VILLAGE STAFF REPORT OF JULY 13, 2015

The petitioner is requesting several approvals for the development of the 2.01 acre site located at the southeast corner of STH 50 and 94th Avenue (Outlot 21 of Prairie Ridge Subdivision) based on the Conceptual Plan that was conditionally approved by the Village Board on June 1, 2015 for the development of two (2) retail/restaurant buildings on the property generally located at the southeast corner of STH 50 (75th Street) and 94th Avenue within the Prairie Ridge development. The approvals being considered by the Plan Commission at this meeting include a Certified Survey Map, a Zoning Text Amendment and Preliminary Site and Operational Plans.

TO: Jean Werbie-Harris, Community Development Director
FROM: Doug McElmury, Chief Fire & Rescue Department
CC: Deputy Chief, Craig Roepke
Lt. Thomas Clark, Fire & Rescue Department
Peggy Herrick, Assistant Planner, Community Development
SUBJECT: Review of the Preliminary Site and Operational Plan for Out lot 21, Multi-tenant Retail
DATE: 10 July 2015

12 SIDEWALK / BARRIER CURB (TYPICAL SECTION)
NOT TO SCALE

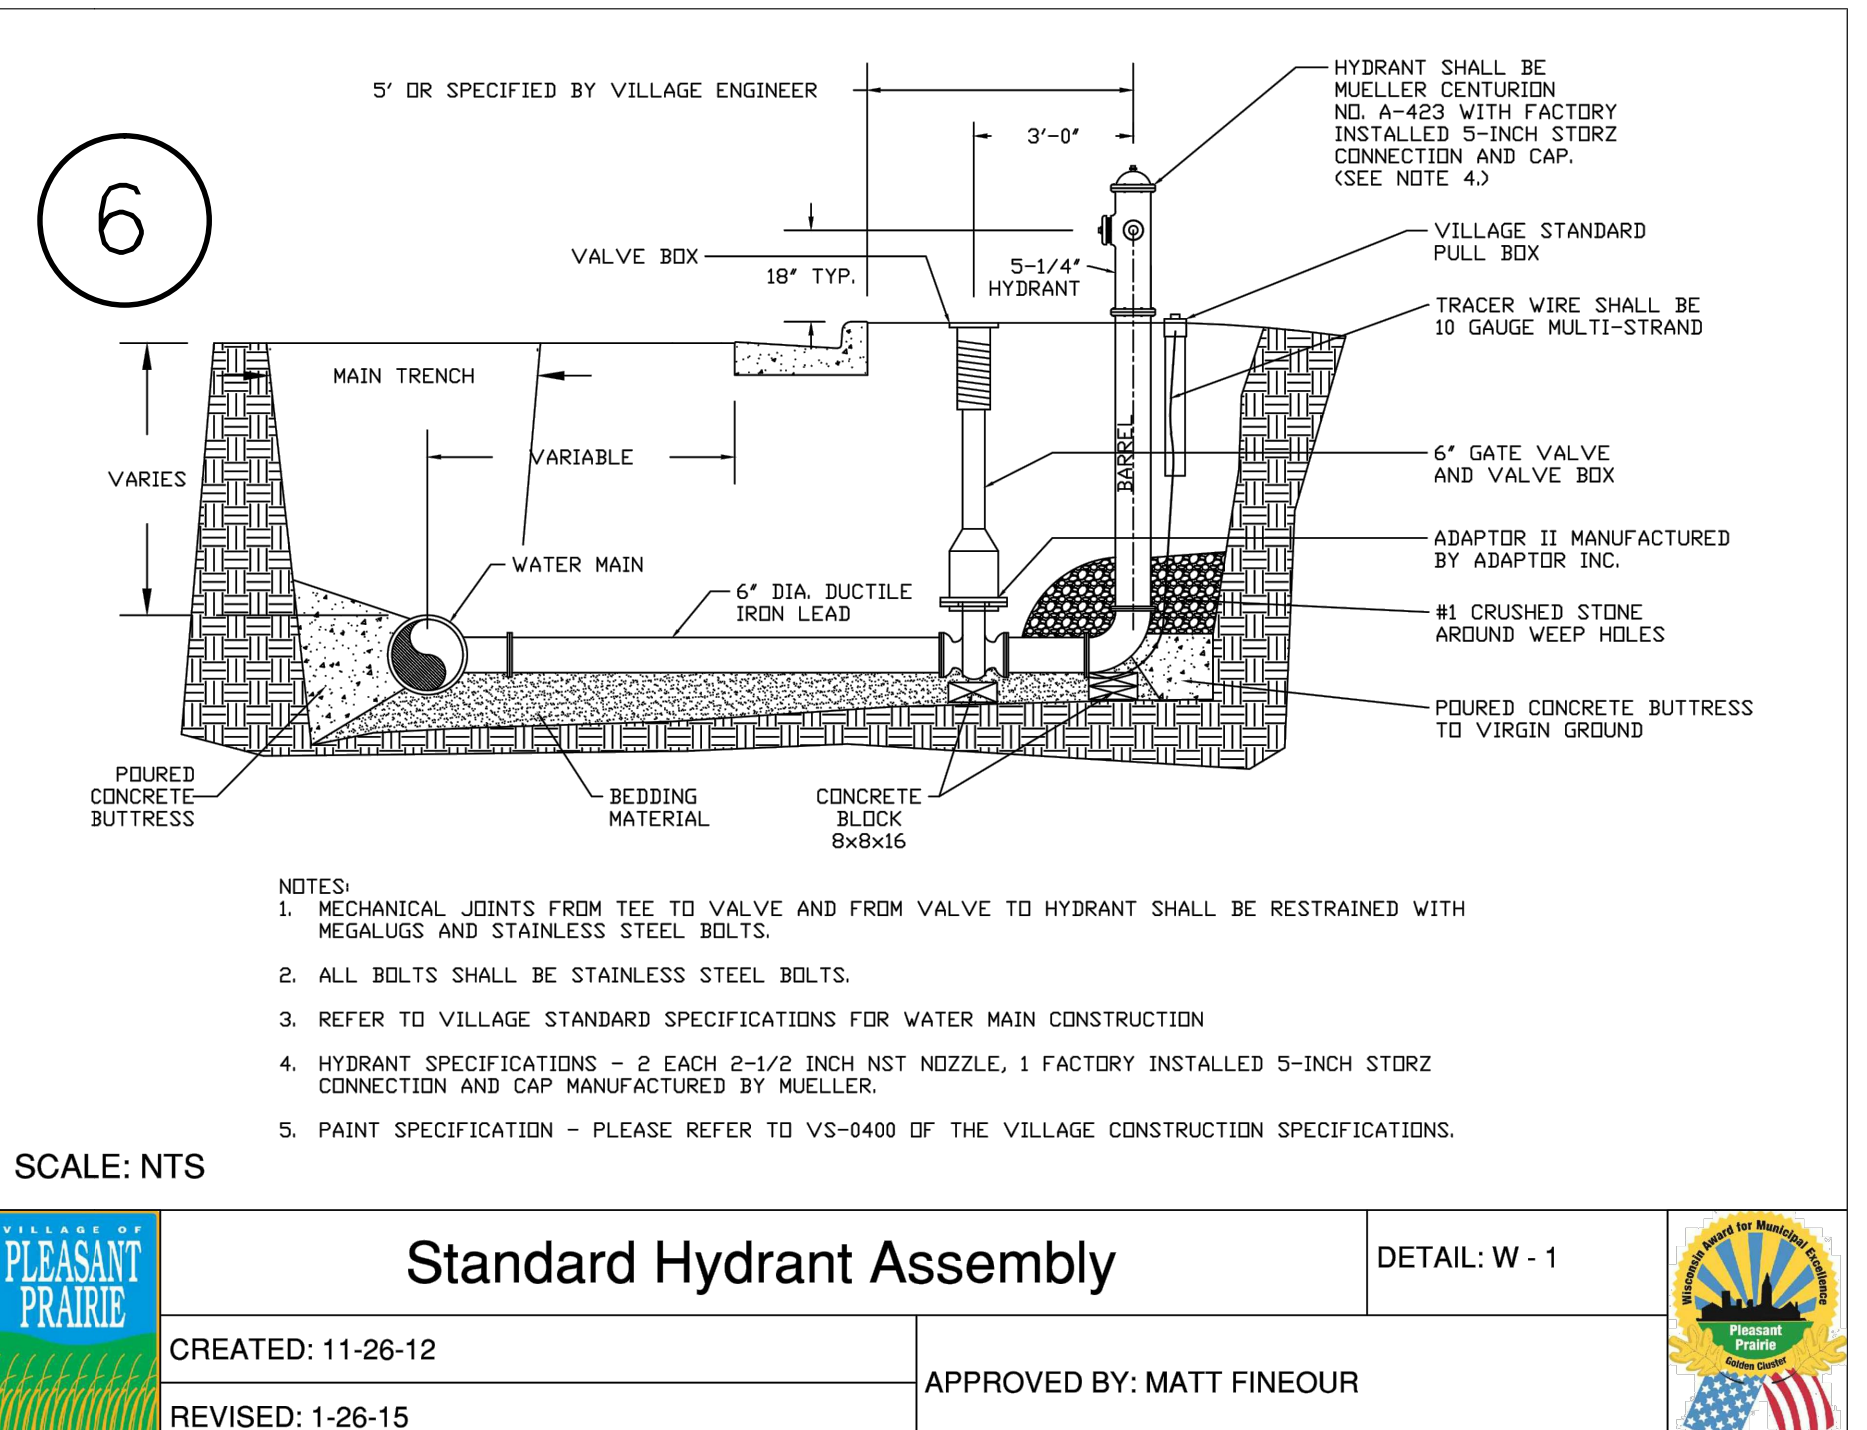
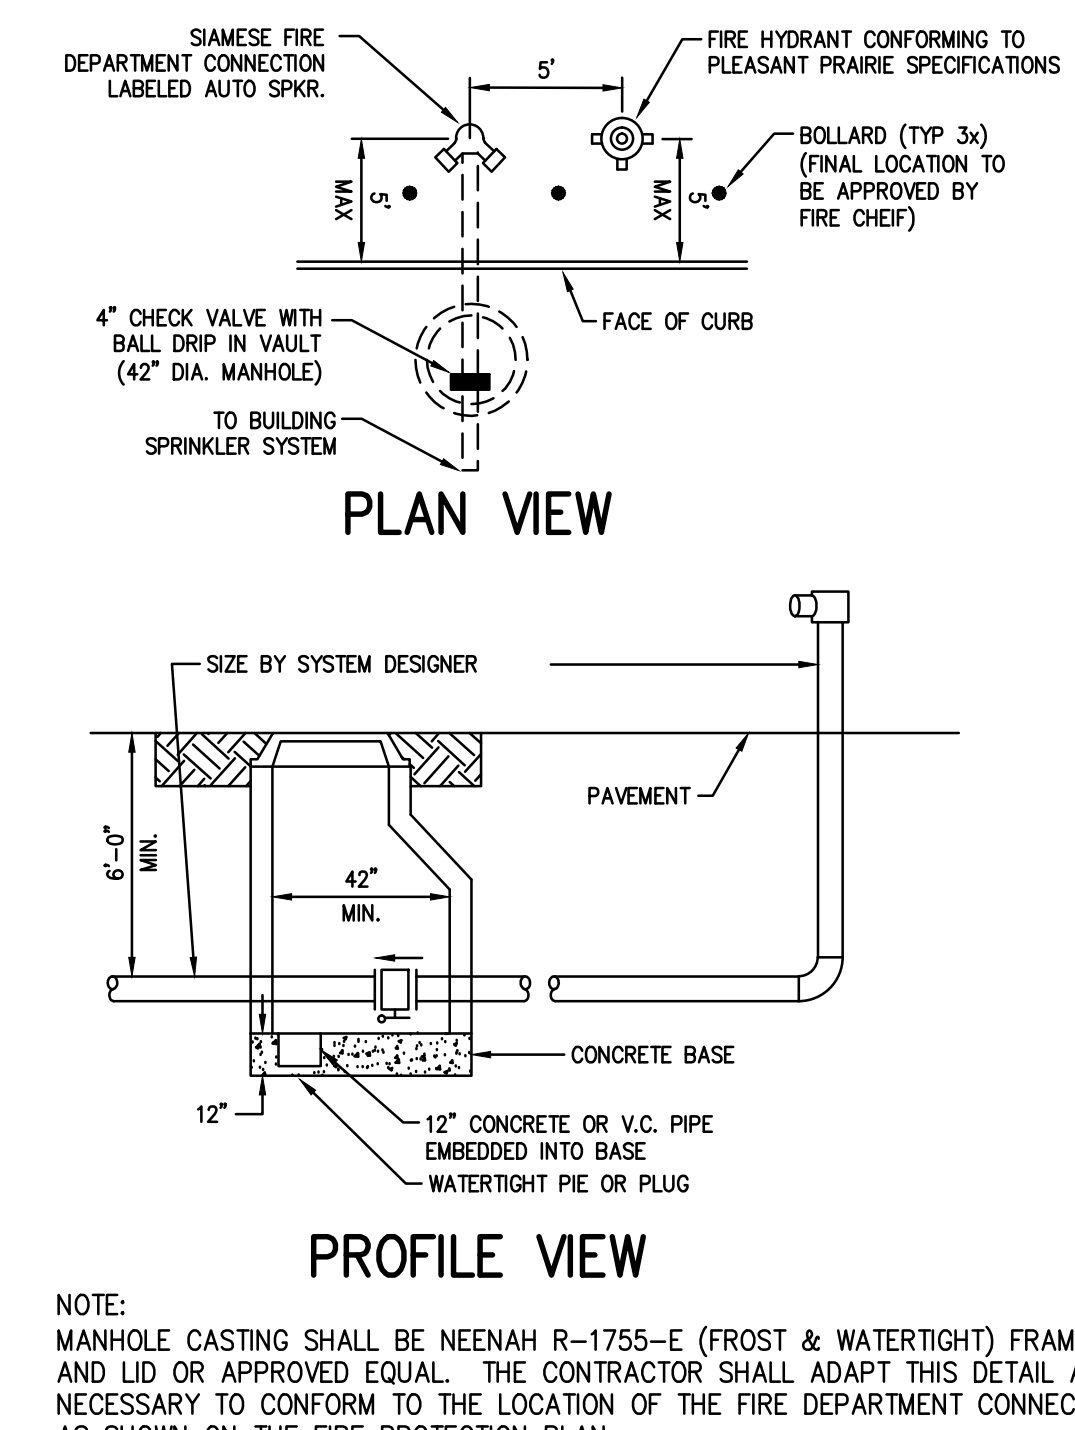
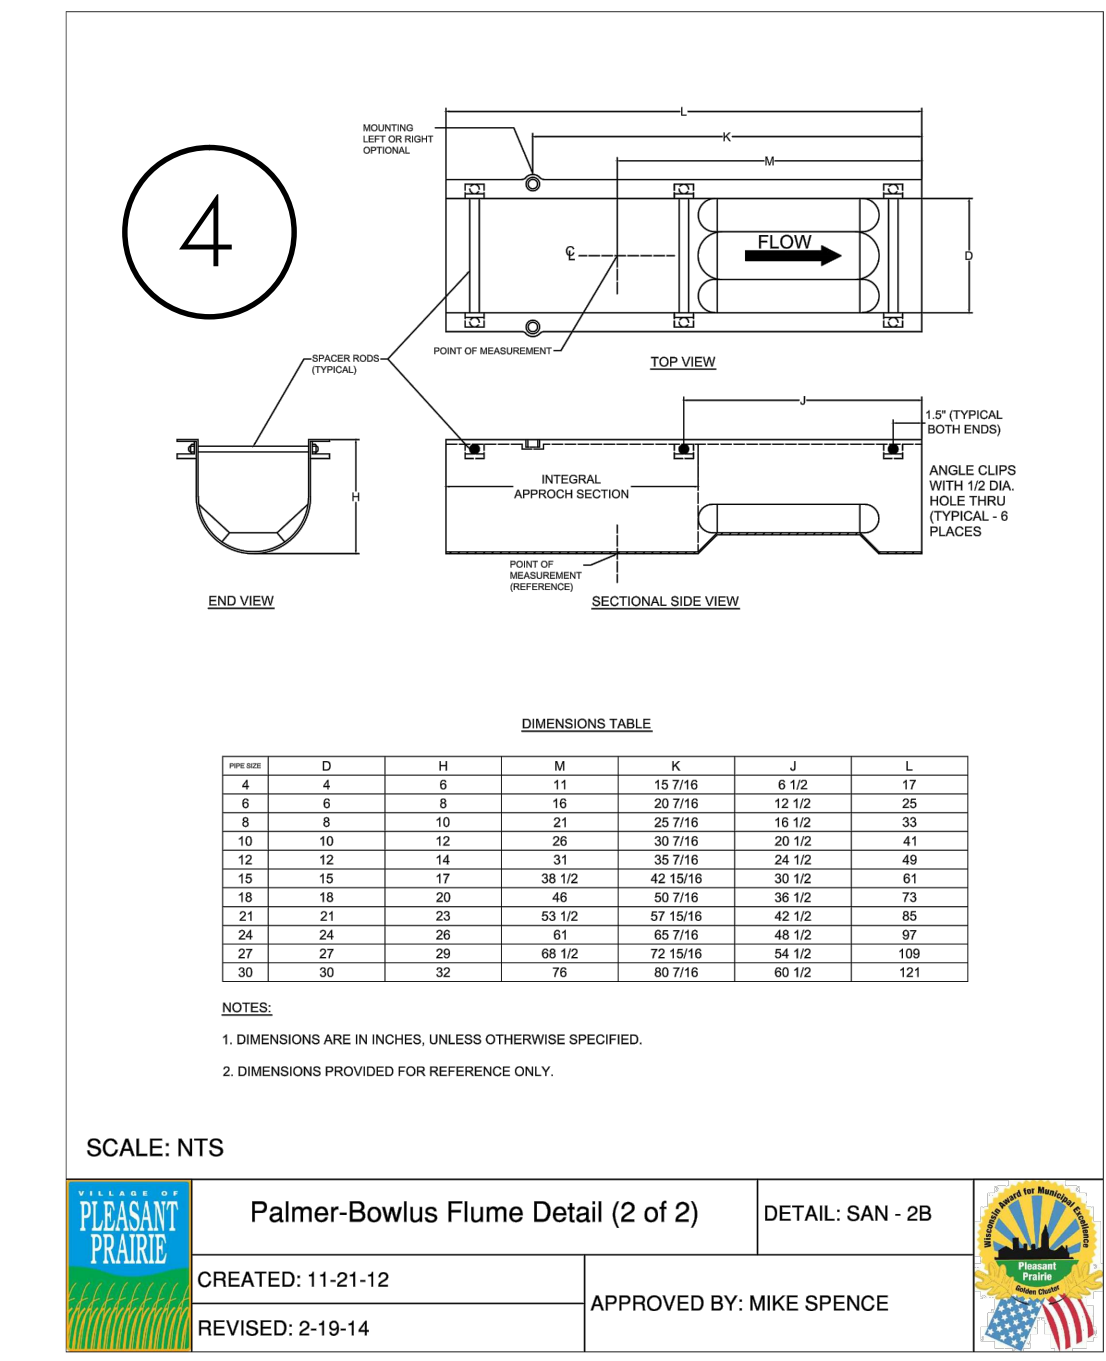
- m. On the Typical Sections and Construction Details (Sheet C-11): Is the casting on the standard inlet detail correct? The detail shows a casting for roll type curb with a width of 24" but the plans call for 18" vertical faced curb and gutter.

- Drawing C-11 shows the incorrect Remote FDC at the Pumper Pad. The FDC shall be built per the current Village Specification including a single 5" storz.

**MID BLOCK CROSSWALK
TO BE INSTALLED BY
OUTLOT DEVELOPER**

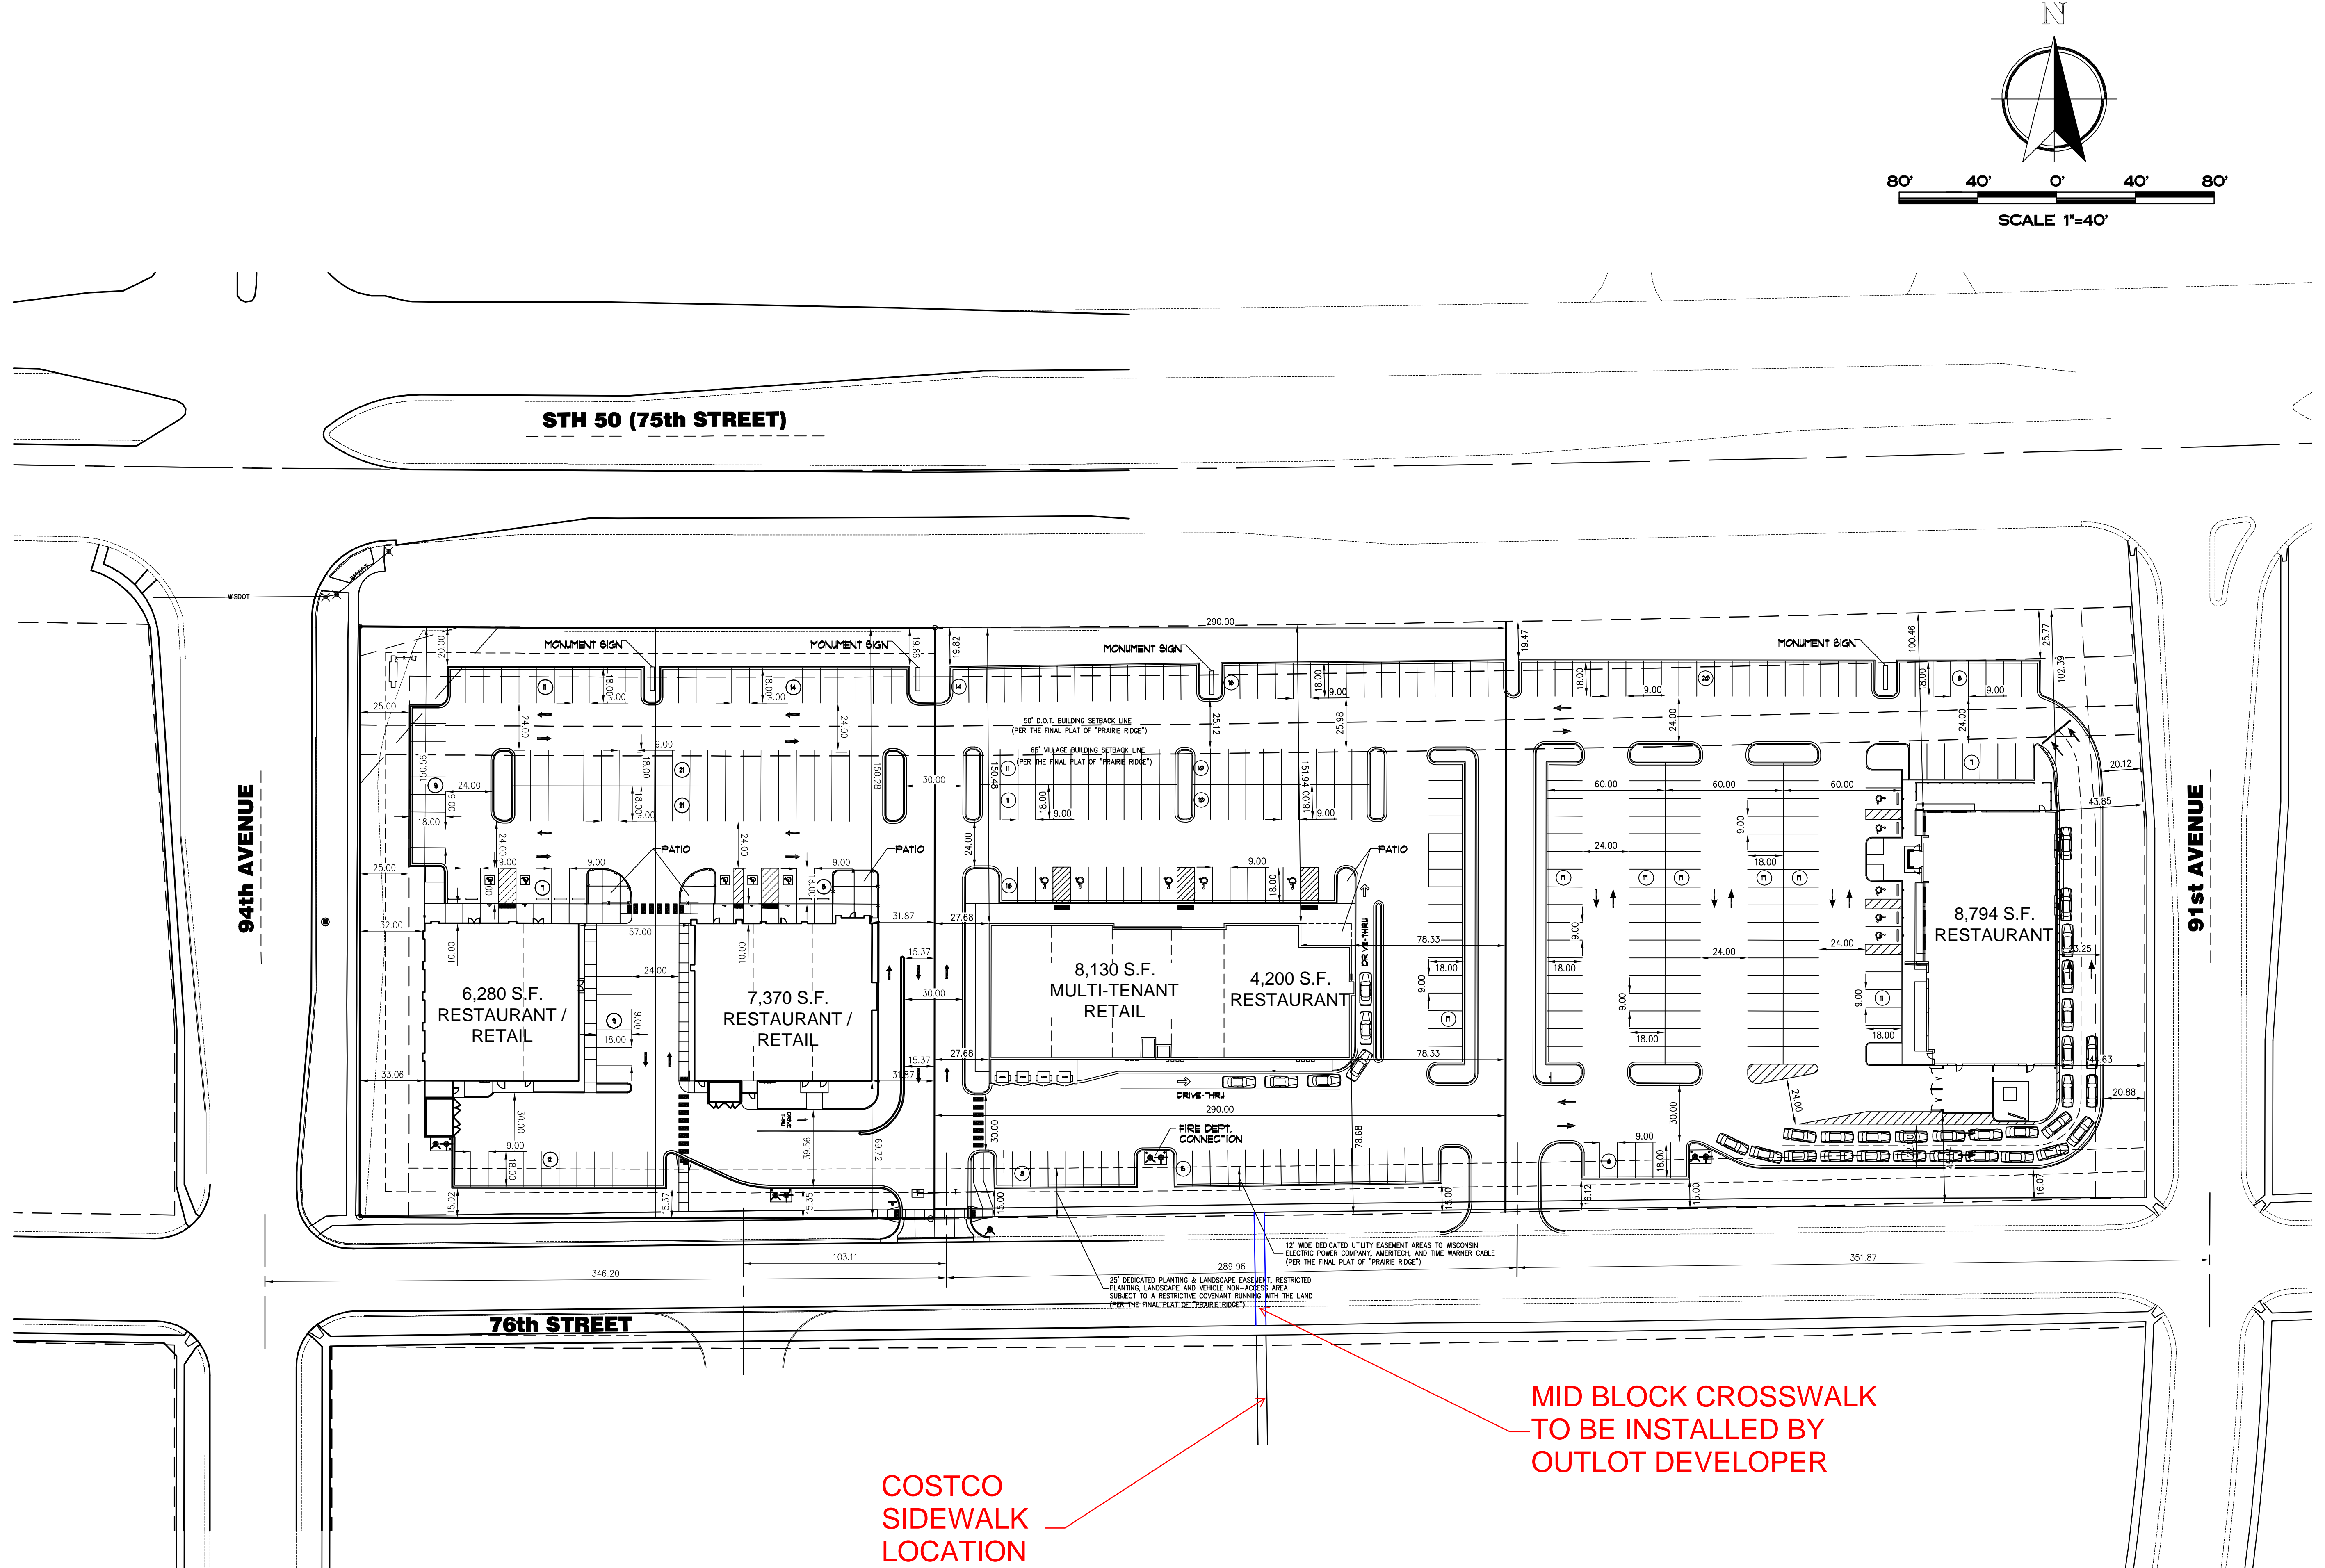
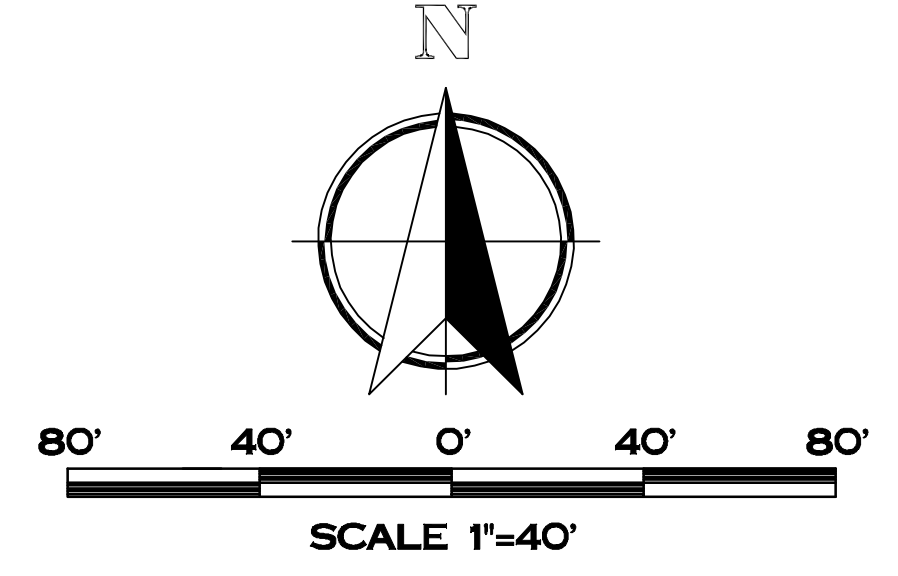
address the potential adjacent cross access parking with Costco, a sidewalk shall be extended to align with the Costco sidewalk connection, along with pavement markings and signage at the developer's cost. This would provide for a mid-block crossing of pedestrians from the Costco parking area to the Outlots 21 and 20 developments.
